UPDATED RESPONSES TO THE  
U.S. NUCLEAR REGULATORY COMMISSION  
REQUEST FOR ADDITIONAL INFORMATION  
ON THE WEST VALLEY DEMONSTRATION PROJECT  
PHASE 1 DECOMMISSIONING PLAN

RAIs 5C6, 5C7, 5C9, 5C10, 5C12, 5C15, and 5C21

November 6, 2009

U.S. Department of Energy  
West Valley, New York

**Figure 5C6-1 Recreationist Conceptual Model Cross Section**

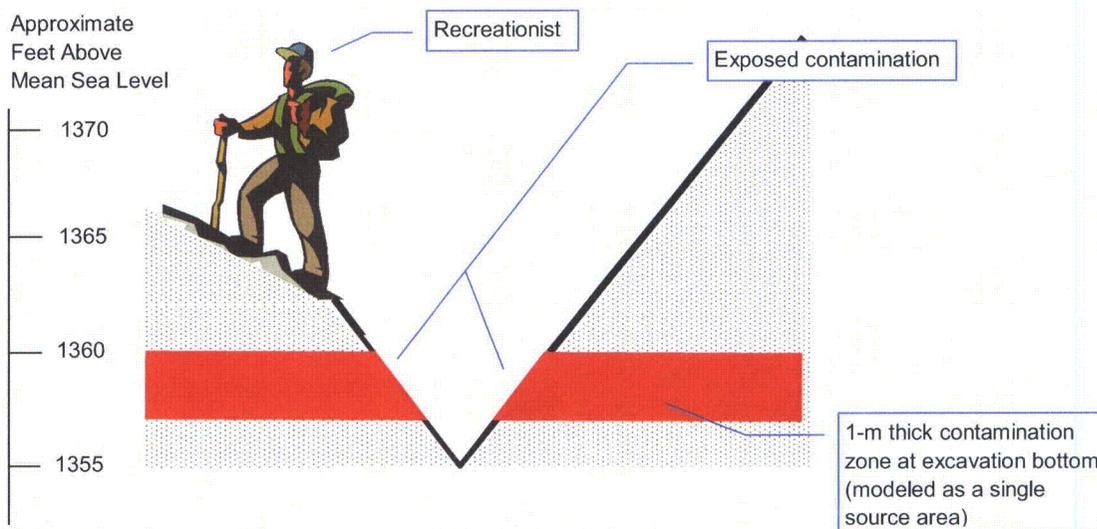
DOE acknowledges that gully erosion could intrude upon the lagoon areas (see page 5-14). However, DOE did not provide quantitative support for its assumption that erosion from gully formation/advancement, or stream widening could intercept the WMA 2 source areas and produce greater exposures to an offsite or onsite receptor.

**Path Forward:** DOE should provide the results of a quantitative analysis that supports its assumption that the subsurface DCGLs calculated assuming a cistern driller scenario bound the potential impacts from erosion.

A plausible scenario for these conditions would involve a recreationist spending time hiking in the area, which is assumed to be rent by deep gullies that extend to the bottom of the WMA 2 excavation. Figure 5C6-1 illustrates the basic conceptual model. This scenario was analyzed using RESRAD in the deterministic mode with the following key conceptual model input parameters:

- The exposed contamination zone area in the gully walls is assumed to be two meters wide and 100 meters long, a reasonable size to represent the likely geometry of the exposed contamination in the gully (modeling a single source area rather than the two illustrated in Figure 5C6-1 was more practical);

Figure 5C9-1. Pre-2007 Inferred Areal Extent of the Lavery Till Sand in the North Plateau

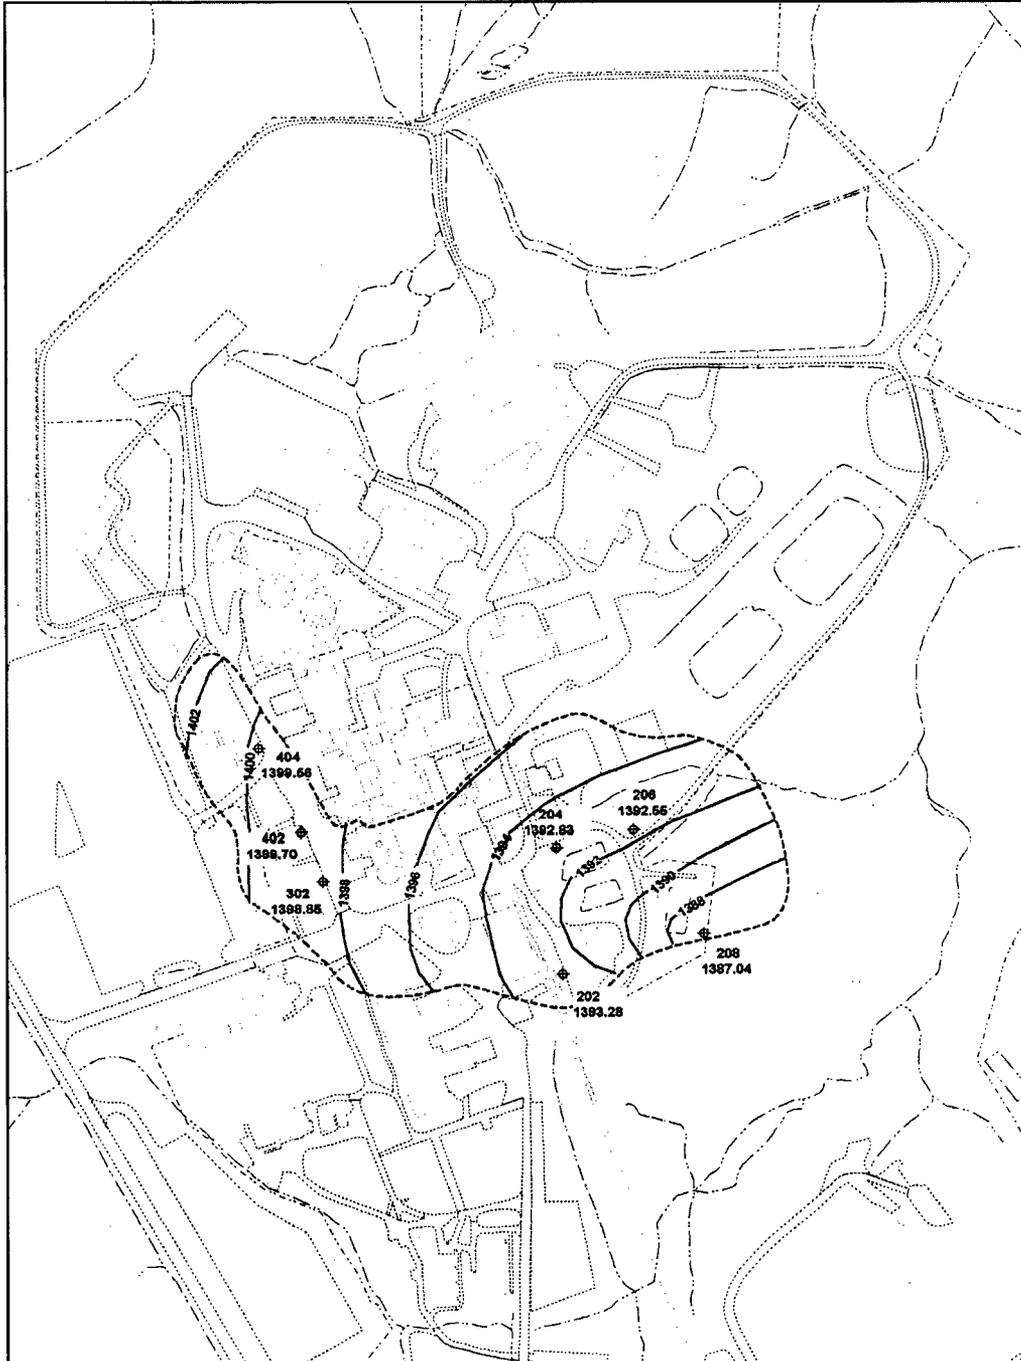
Additional information may be needed to support the hydrogeological conceptual model for contamination assumed to be present underneath WMA 1 and 2 used to derive subsurface DCGLs. Previous geologic interpretations showed contamination of a significant portion of the Lavery Till and Lavery Till Sand underneath the Main Plant Process building that could lead to pathways of exposure not considered in the current analysis. DOE should indicate how it plans to manage the risk associated with significantly greater contamination levels at depth along H-piles or within the Lavery Till then were assumed in the DCGL calculations.

**Path Forward:** DOE could provide additional information such as borehole logs for those locations where the top of the Lavery Till was significantly lowered and the Lavery Till Sand eliminated underneath the process building in the vicinity of the source of the North Plateau groundwater plume. Additional cross-sections overlaying recent concentration data over reinterpreted geology underneath the process building would also provide additional confidence in the revised hydrogeological conceptual model.

The Lavery till sand is not located beneath the Process Building nor within the north plateau groundwater plume and previous interpretations of the extent of this unit have not suggested its location beneath the Process Building. Re-examination of borehole logs from the north plateau in 2007 resulted in a re-evaluation of the areal extent of the Lavery till sand. Copies of the borehole logs that were used to revise the extent of the Lavery till sand are attached. Table 5C9-1 (which appears at the end of the text) summarizes the revisions to the geologic interpretation of the boring logs used to delineate the extent of the Lavery till sand as described in Figure 3-64 of the DP.

From 1991 to 2007 the Lavery till sand was inferred to be present to the west, south, and southeast of the Process Building in a location that was hydraulically upgradient and cross-gradient to the north plateau groundwater plume (Figure 5C9-1). Earlier interpretations of the borehole logs considered a prominent clay-rich geologic horizon up to several feet in thickness as part of the unweathered Lavery till and the underlying sandy unit as the Lavery till sand.

**Figure 5-10. Modified Conceptual Model for Subsurface Soil DCGL Development**

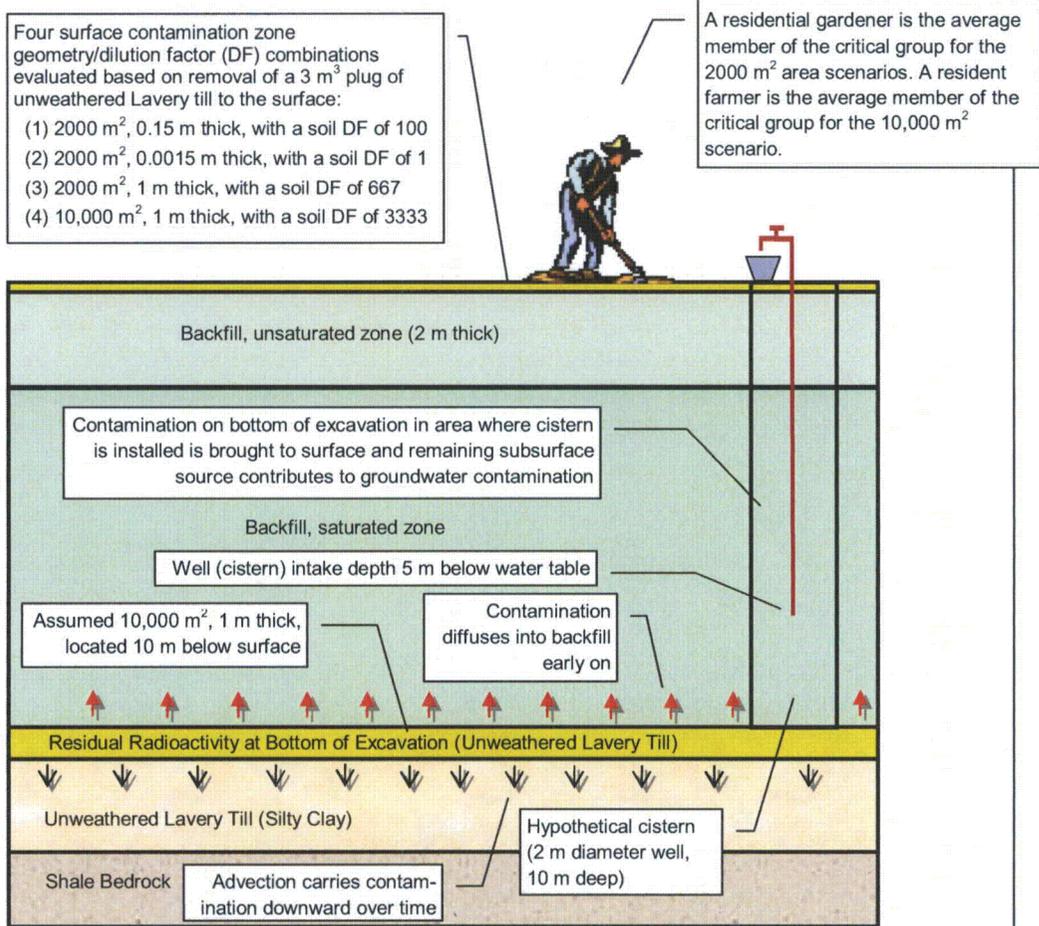
DOE should clarify how the residual risk from contaminated soil located just below 1 m (e.g., on the sides of the excavations) is appropriately accounted for when comparing residual concentrations to subsurface DCGLs which assume the contamination is mixed with clean soil at a ratio of one to ten (i.e., dilution factor of ten). DOE indicates in a footnote on page 5-4 that contamination on the sides of the excavation up- and cross-gradient from the source area is not

As discussed in a preceding comment, it is recommended that DOE provide results of calculations or perform additional modeling (e.g., multi-dimensional groundwater modeling using STOMP) to show the impacts of (i) a pumping well, and (ii) hydraulic barriers on the flow field in the immediate vicinity of WMA 1 and 2 excavations and potential transport of contaminants from the Lavery Till to a the drinking water well located in the sand and gravel. DOE should also evaluate the potential risk associated with transport of contamination from the Lavery Till to the KRS or to surface water. This information could be used to provide additional support that the potential contributions from subsurface contamination to the overall risk from the site from other pathways of exposure (i.e., drilling scenario) are insignificant.

The base-case conceptual model that had been used for development of the subsurface soil DCGLs using RESRAD was modified to provide for a multi-source approach. Two potential sources were considered. First, a plug of Lavery till with residual contamination from the excavation bottom is brought to the surface during installation of the cistern and spread over the entire surface of the hypothetical garden. In addition, the remaining contaminated Lavery till is considered a subsurface source that produces a continuing release of contamination from the Lavery till at the excavation bottom into the clean backfill, where residual radioactivity moves upward by diffusion and contaminates the aquifer resulting in additional doses. Both the residential gardener scenario and the resident farmer scenario were evaluated.

The excavation bottom is treated as two distinct sources: (1) a plug of contaminated soil from the excavation bottom that is brought to the surface during installation of the cistern and spread over the entire surface of the hypothetical garden, and (2) the remaining contaminated Lavery till at the excavation bottom from which residual radioactivity moves upward by diffusion and enters groundwater being drawn into the well. Both the residential gardener scenario and the resident farmer scenario were considered as indicated in Figure 5-10.
